UNITED STATES PATENT AND TRADEMARK OFFICE

APPLICATION NO.	FILING DATE	FIRST NAMED INVENTOR	ATTORNEY DOCKET NO.	CONFIRMATION NO.
10/747,716	12/29/2003	Kuo-Chang Yang	251702-1310	5874
24504	7590	09/19/2005		
THOMAS, KAYDEN, HORSTEMEYER & RISLEY, LLP 100 GALLERIA PARKWAY, NW STE 1750 ATLANTA, GA 30339-5948			EXAMINER CHANDRAN, BIJU INDIRA	
			ART UNIT 2835	PAPER NUMBER

Office Action Summary	Application No.		Applicant(s)	
	10/747,716		YANG ET AL.	
	Examiner		Art Unit	
	Biju Chandran		2835

Jones et al. (U.S. Patent 5,519,585) in view of Chuang (U.S. Patent 6,469,912 B1).

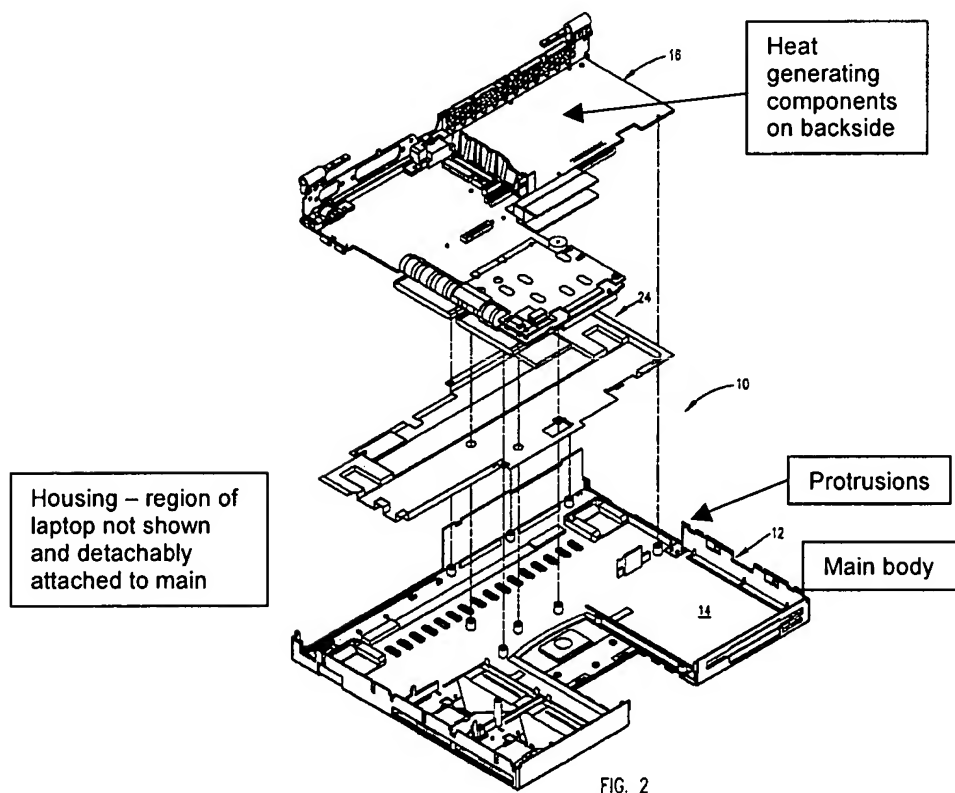
- Regarding claim 1, Jones et al. discloses an electronic device, comprising: a main body (12); a thermal insulation layer (44) (column 4, line 30) disposed on the inner surface of the main body; a conductive layer (46) fully covering the surface of the thermal insulation layer (column 3, line 41); an electrical insulation layer (48) partially covering the conductive layer (column 3, lines 55-60), leaving part exposed to dissipate heat from the electronic device. Jones et al. do not expressly disclose a hatch for the electronic device. Chuang discloses a hatch for an electronic device. At the time the invention was made, it would have been obvious to a person of ordinary skill in the art to incorporate the invention of Jones et al. in the hatch of the electronic device disclosed by Chuang, to reduce the cost and improve the effectiveness of EMI barriers (Jones et al., column 3, line 10-20).

- Regarding claim 7, Jones et al. further disclose a hole (40) in the main body.
- Regarding claim 8, Jones et al. further disclose protrusions on the edge of the main body.
- Regarding claim 9, Jones et al. further disclose the electronic device to be a notebook computer (column 2, line 65).

- Regarding claim 10, Jones et al. disclose a notebook computer having a housing (regions of laptop not shown in figure) comprising: a main body (12) detachably disposed on the housing; a thermal insulation layer (44) disposed on a side of the main body, wherein the side is adjacent to heat-generating components (22); a conductive layer (46) covering the surface of the thermal insulation layer (column 3, line 41); an electrical insulation layer (48) partially covering the conductive layer, leaving part of the conductive layer is exposed (column 3, line 55-60), and heat from the component is insulated by the thermal insulation layer. Jones et al. do not explicitly disclose a hatch for the electronic device. Chuang discloses a hatch for an electronic device. At the time the invention was made, it would have been obvious to a person of ordinary skill in the art to incorporate the invention of Jones et al. in the hatch of the electronic device disclosed by Chuang, to provide and an access port for the user to replace components without having to dismantle the electronic device.
